Title: **QUALITY AUDIT
INCLUDING ROAD SAFETY AUDIT STAGE 1
Proposed Residential Development at Glenamuck Road**

Client: **DBFL Consulting Engineers**

Date: **November 2020**

Report reference: **0878R01**

Drawing 170063-2100 Rev P02, Toucan Crossing Glenamuck Road.

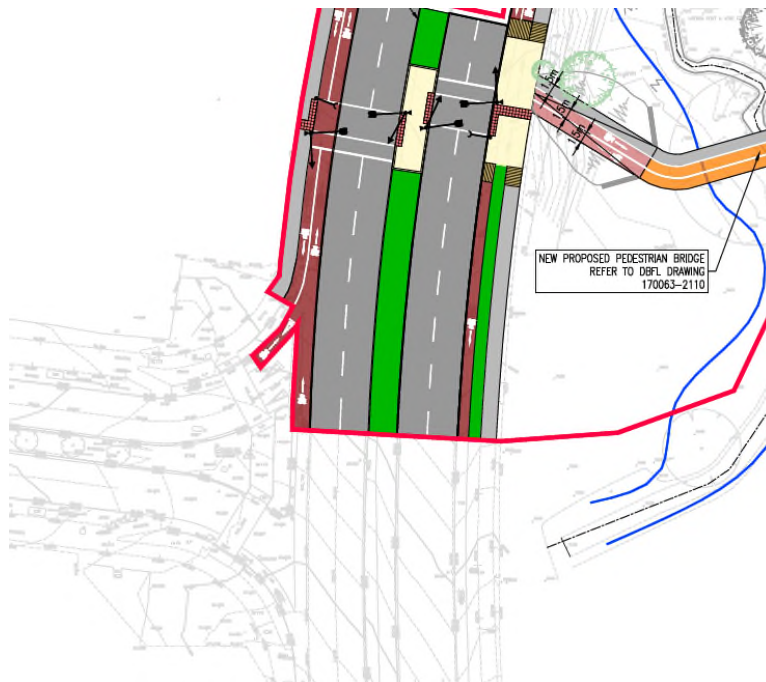
The audit team have concerns regarding the location of the toucan crossing on the western side of Glenamuck Road. As there is a good level of visibility to the right for vehicle drivers travelling along the Carrickmines Park Shopping centre's egress lanes (in advance of the immediate approach to the junction), vehicle drivers can clearly see (in advance of the junction) if there are oncoming vehicles on Glenamuck Road. If there are no vehicles approaching in both (or the nearside) lanes on Glenamuck Road, vehicle drivers were observed to exit The Carrickmines Park Shopping centre without stopping/yielding at the junction. Due to these rapid exit practices being undertaken, vehicle drivers may fail to acknowledge the toucan crossing signals located immediately to the left of the junction in sufficient time to stop. This could result in conflict with pedestrians/cyclists crossing the carriageway.

It is recommended that the toucan crossing be moved further away from the junction or that the junction of The Carrickmines Park Shopping Centre is altered to ensure that vehicles exiting onto Glenamuck road are travelling at a very low speed.

3.1	Yes	Yes	We acknowledge the auditor’s concern and agree with the recommended measure, however the area is outside the control/ownership of the applicant and in the ownership of a DLRCC. We agree to notify DLRCC of the problem for their attention. Should DLRCC condition the applicant for its relocation and grant the necessary licenses then same will be facilitated.	Yes

Drawing 170063-2100 Rev P02, Toucan Crossing Glenamuck Road.

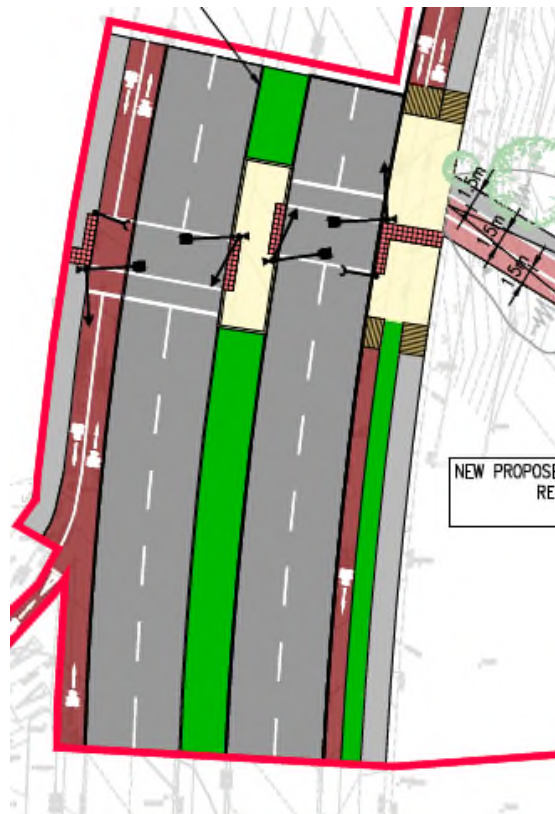
There is an existing median hedge on Glenamuck Road dual carriageway. It is unclear if the hedge is to be cleared and if so to what extent. Without sufficient clearance of the median hedge inter-visibility between crossing cyclists and pedestrians with oncoming drivers may be limited leading to collisions.

It is recommended that the median hedge be cleared for sufficient distance in both directions to ensure adequate visibility to crossing vulnerable road users.

3.2	Yes	Yes	We acknowledge the auditor’s concern and agree with the recommended measure, however the area is outside the control/ownership of the applicant and in the ownership of DLRCC. We agree to notify DLRCC of the problem for their attention. Should DLRCC condition the applicant for the recommendation and grant the necessary licenses then same will be facilitated.	Yes

Drawing 170063-2100 Rev P02, Toucan Crossing Glenamuck Road.

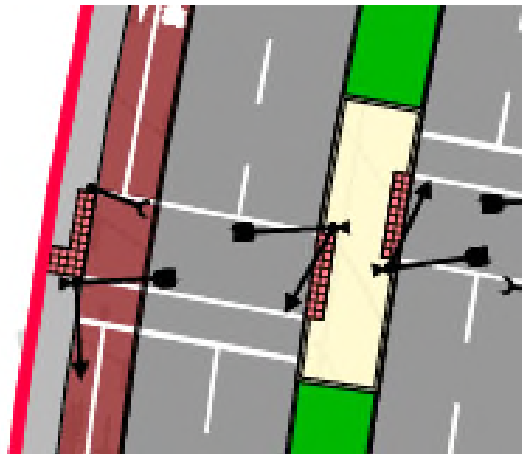
Cyclists on the western side of Glenamuck Road may collide with crossing pedestrians if they do not expect them to cross at the proposed toucan crossing.

It is recommended that the toucan signals be provided at the carriageway edge rather than at the back of the cycle track and that a shared area be provided for pedestrians and cyclists to share.

3.4	Yes	Yes	We acknowledge the auditor's concern and agree with the recommended measure, however the area is outside the control/ownership of the applicant and in the ownership of DLRCC. We agree to notify DLRCC of the problem for their attention. Should DLRCC condition the applicant for the recommendation and grant the necessary licenses then same will be facilitated.	Yes

Drawing 170063-2100 Rev P02, cycle track to basement.

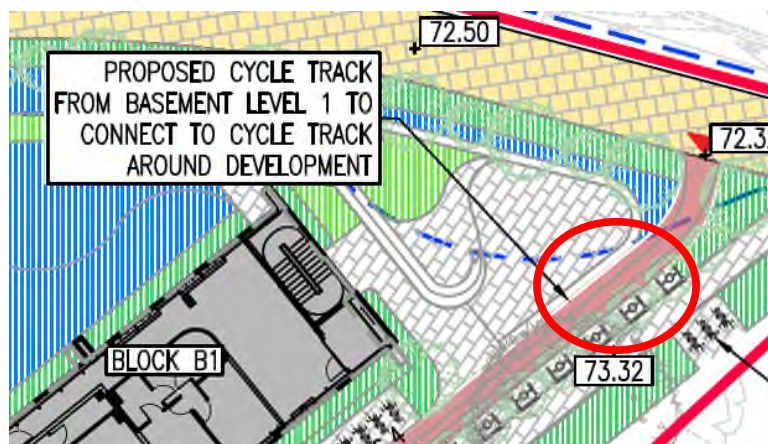
It is unclear what width the two-way cycle ramp to the basement is. If it is too narrow, there is a risk of collision between passing cyclists. The speed differential could be high given the high gradients which could lead to higher severity injuries.

It is recommended that the two-way cycle lane to and from the basement is of suitable width to accommodate fast moving cyclists.

3.6	Yes	Yes		
3.7	Yes	Yes		
3.8	Yes	Yes	We acknowledge the auditor's concern and agree that a future bus stop along Golf Lane will be of benefit, however the area is outside the control/ownership of the applicant and in the ownership of a DLRCC. We agree to notify DLRCC of the problem for their attention. Should DLRCC condition the applicant for its relocation and grant the necessary licenses then same will be facilitated.	Yes

Drawing 170063-2101-P02, Basement level 1 Layout.

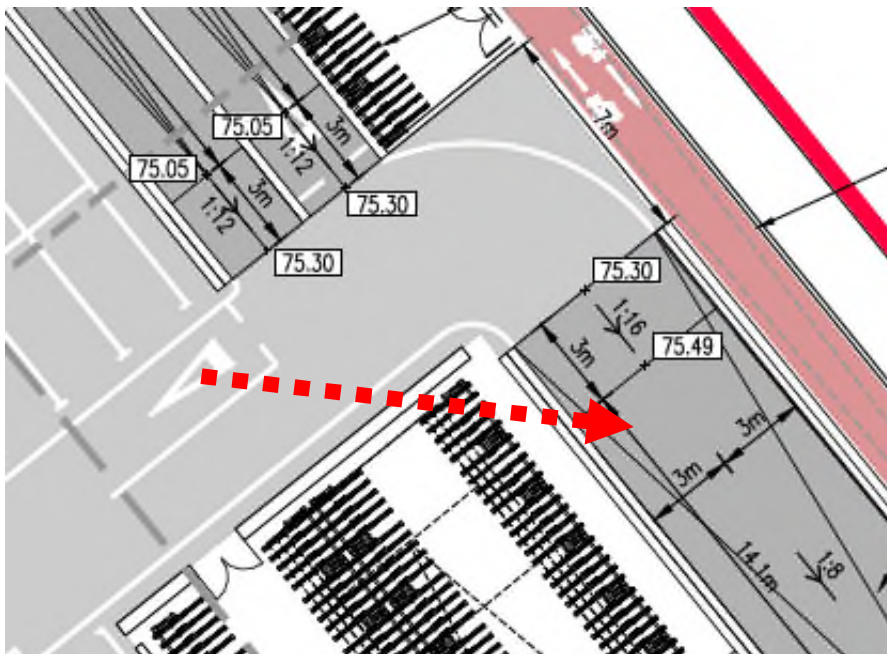
Vehicles exiting the basement have to yield to vehicles entering the basement due to the tight horizontal bend. It is unclear if there will be sufficient visibility for drivers to see if a vehicle is coming down the ramp when at the yield line. Without adequate visibility this could result in head-on collisions or reversing leading to material damage.

It is recommended that a swept path analysis be carried out so that two vehicles can meet or that sufficient visibility is provided at the Yield line.

Paragraph No. in Quality Audit Report	Problem accepted (yes/no)	Recommended measure accepted (yes/no)	Alternative measures (describe)	Alternative measures accepted by Auditors (Yes/No)
3.9	Yes	Yes	We acknowledge the auditor's concern and agree with the recommended measure. A swept path analysis has been carried out which reveals that two vehicles can meet. The obstacles impeding visibility at the yield line will be adjusted during detailed designs to provide sufficient visibility for vehicles.	Yes
3.10	Yes	Yes		
3.11	Yes	Yes	We agree with the recommended measure to provide buffer areas around EV parking spaces. The final locations of these parking spaces will be identified during the detailed design stages of the project in coordination with other services and utilities in the basement.	Yes
3.12	Yes	Yes		
3.13	Yes	Yes		
3.14	Yes	Yes

Drawing 170063-2101-P02, Basement level 1 Layout.

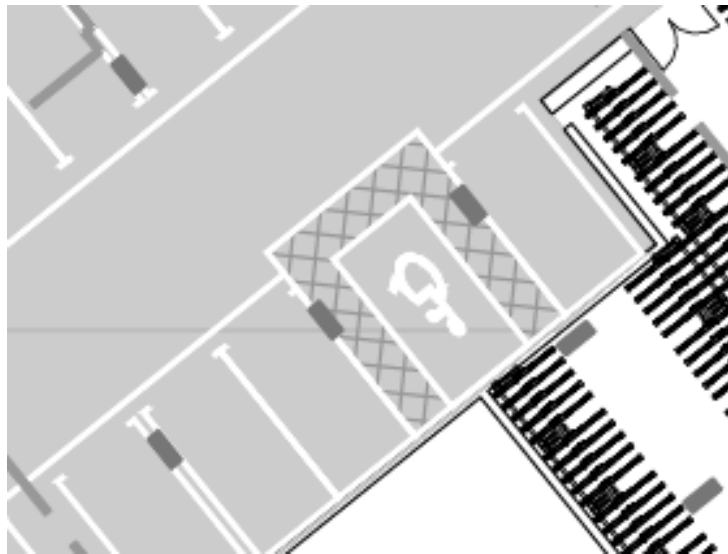
The structural columns appear to be located in the buffer zone around the single disabled parking bay in the south eastern aisle. This could lead to accessibility issues for wheelchair users.

It is recommended that the buffer zone for disabled parking bays be kept free from obstacles.

Drawing 170063-2101-P02, Basement level 1 Layout, bicycle park.

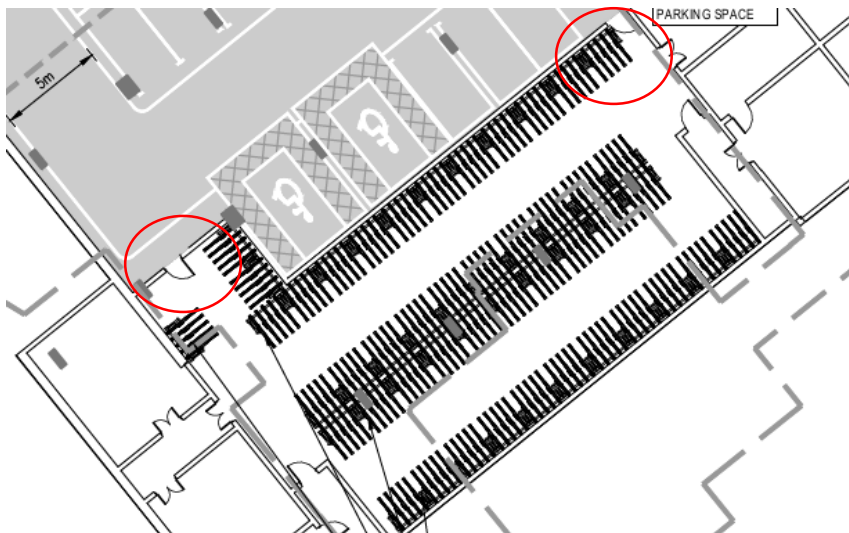
There are two single doors for the large (450no.) bicycle parking area in basement No. 1. The lack of space at the doorways for a busy area could lead to damage of the door/frames and possible cyclist injury and discomfort/frustration.

It is recommended that double doors be used instead of single doors.

Drawing 170063-2110 & 2111-P02, Pedestrian Bridges.

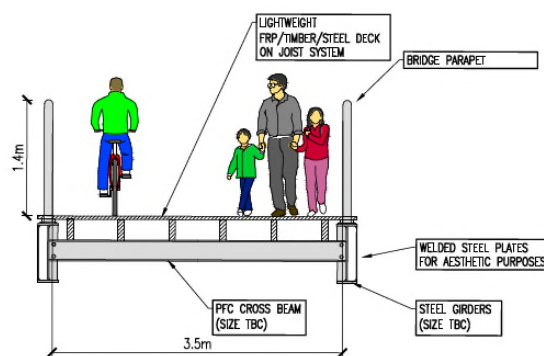
The pedestrian bridge cross sections show a cross sectional width of 3.5m. The cycle track and footpath have an overall cross section of 4.5m & 4.0m. A restriction in width could lead to collisions between cyclists and pedestrians.

It is recommended that the effective width of the bridge be the same as the general facility taking into account the reduction caused by the parapet upstands.

PROJECT: RESIDENTIAL DEVELOPMENT AT GLENAMUCK ROAD
DRAWING TITLE: ROADS LAYOUT
DESIGNED BY: HENRY J. LYONS ARCHITECTS
DESIGNED BY: PCC, BS, SCALE: 1:500, SHEET NO: A1
DRAWING NO: 170063-2-100, P02

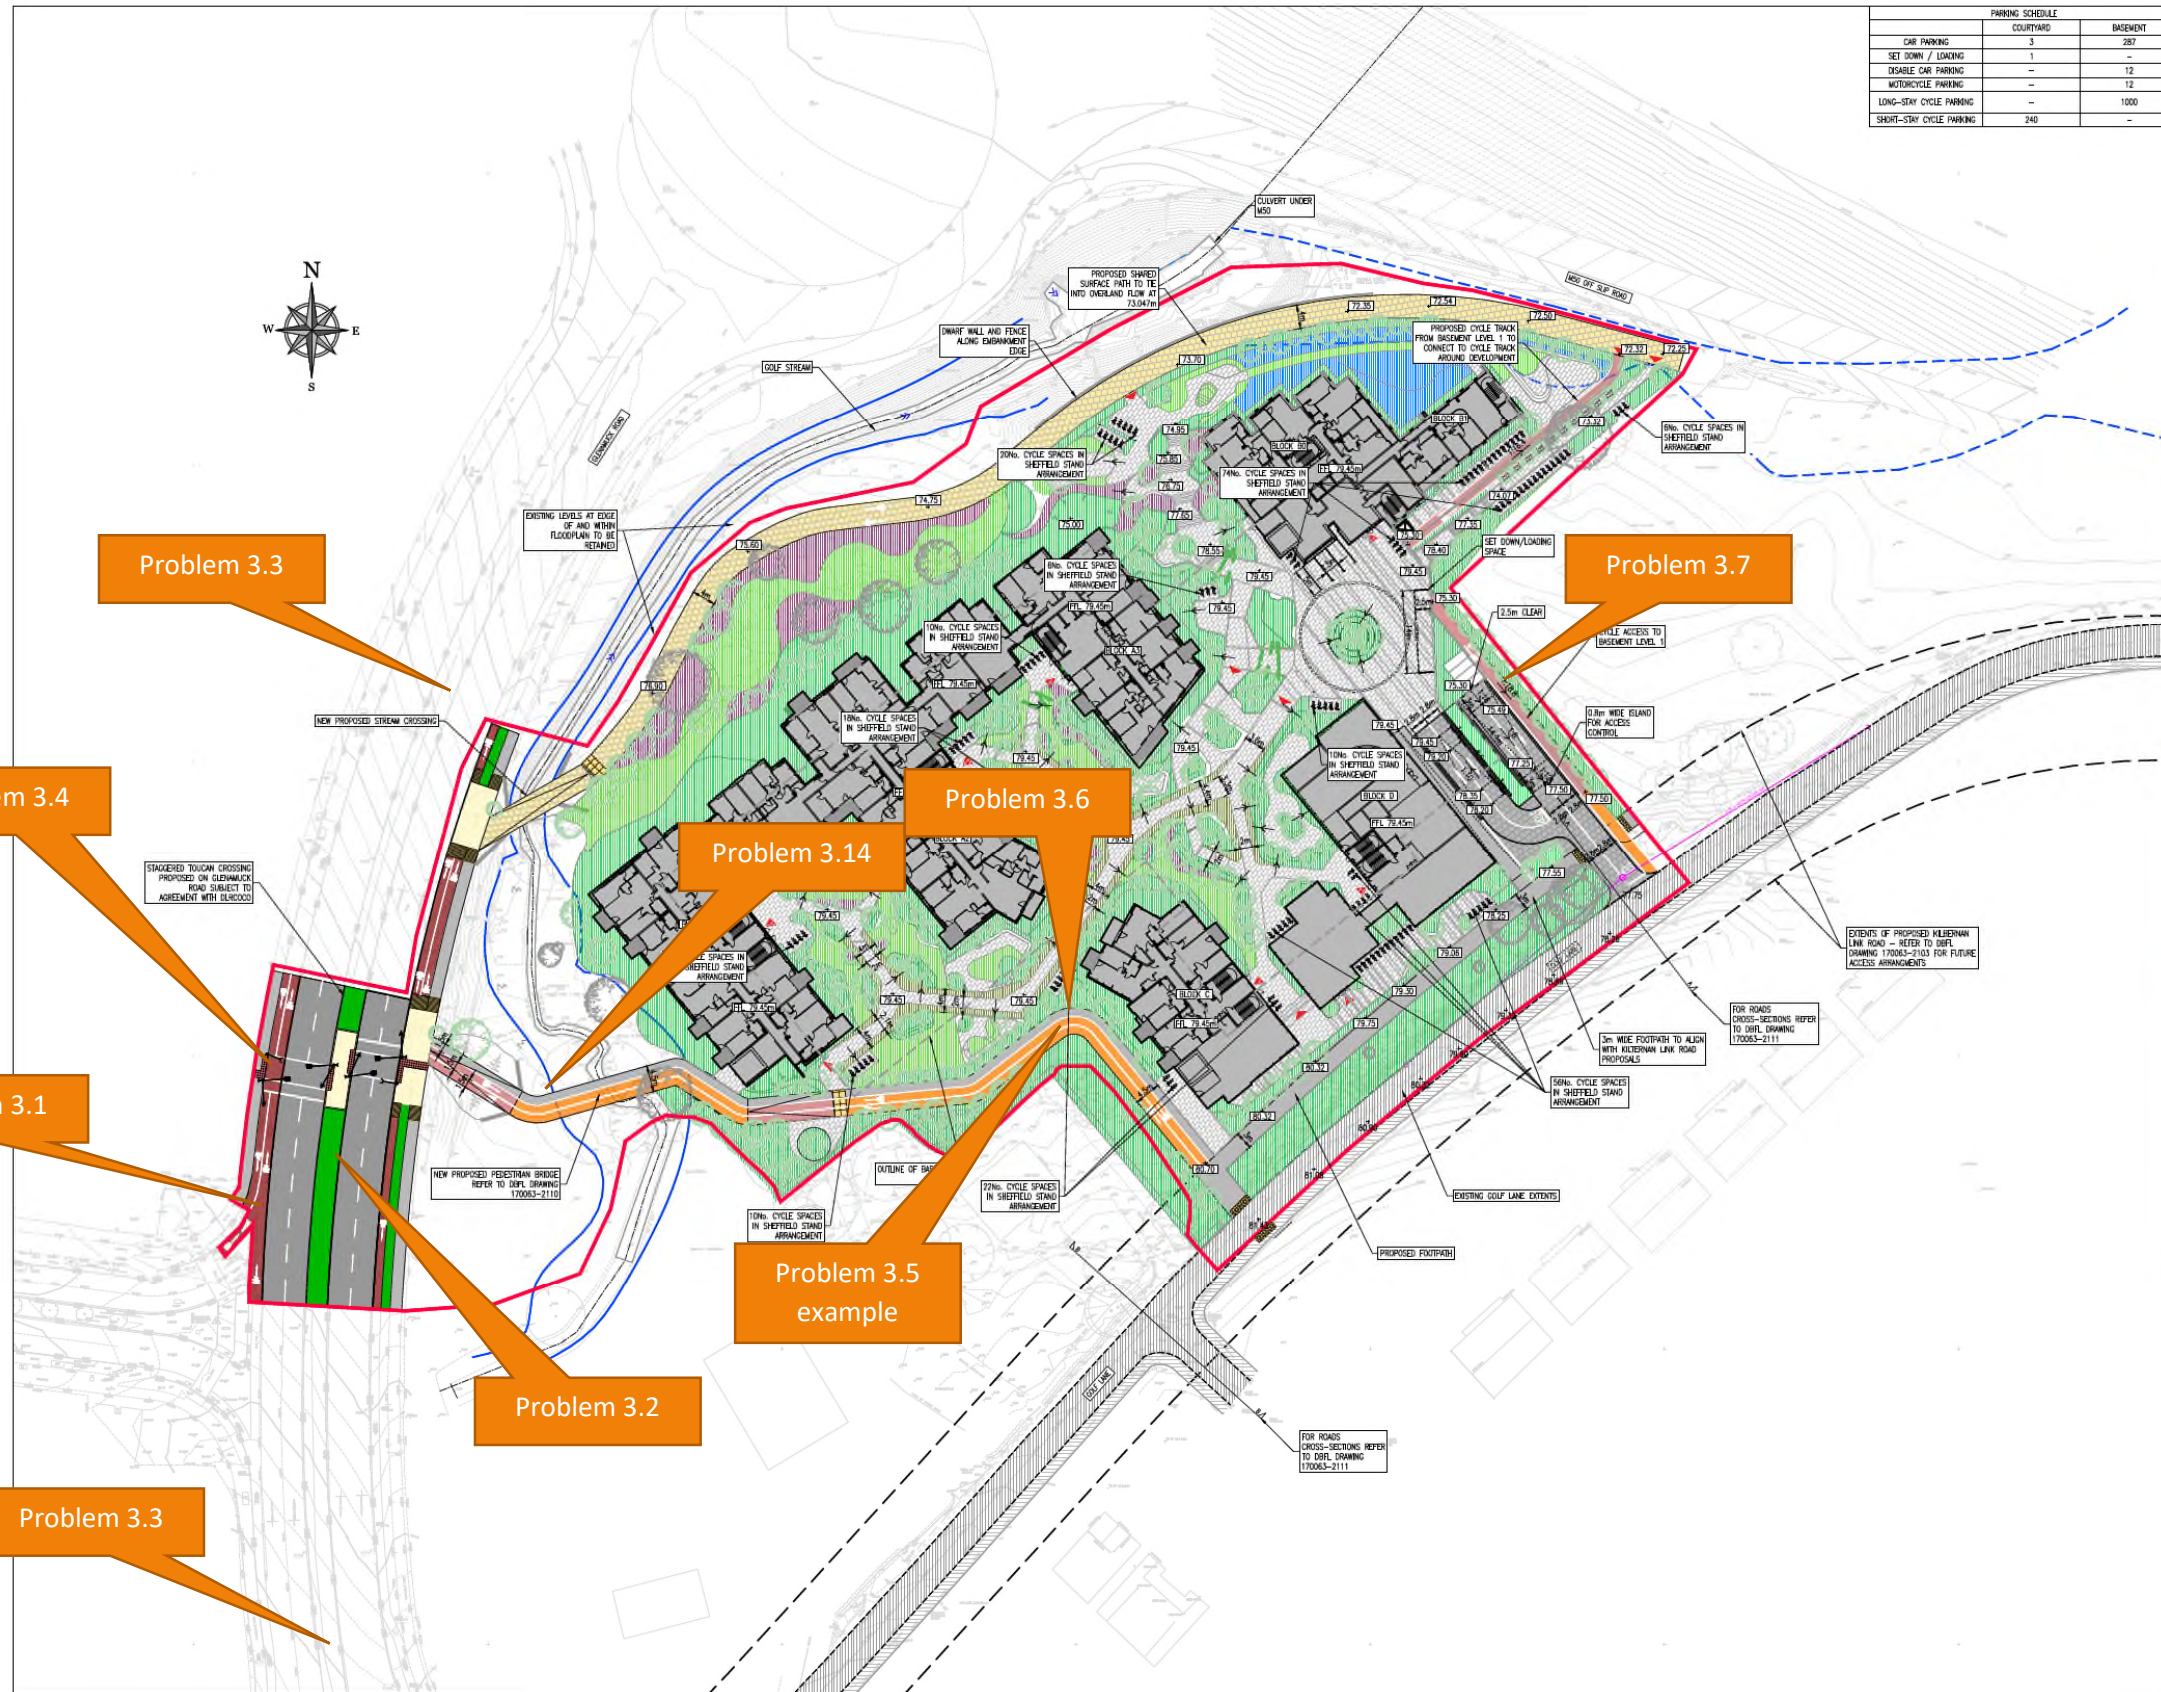
Problem 3.3

Problem 3.7

Problem 3.4

Problem 3.6

Problem 3.1

Problem 3.14

Problem 3.5 example

Problem 3.2

Problem 3.3
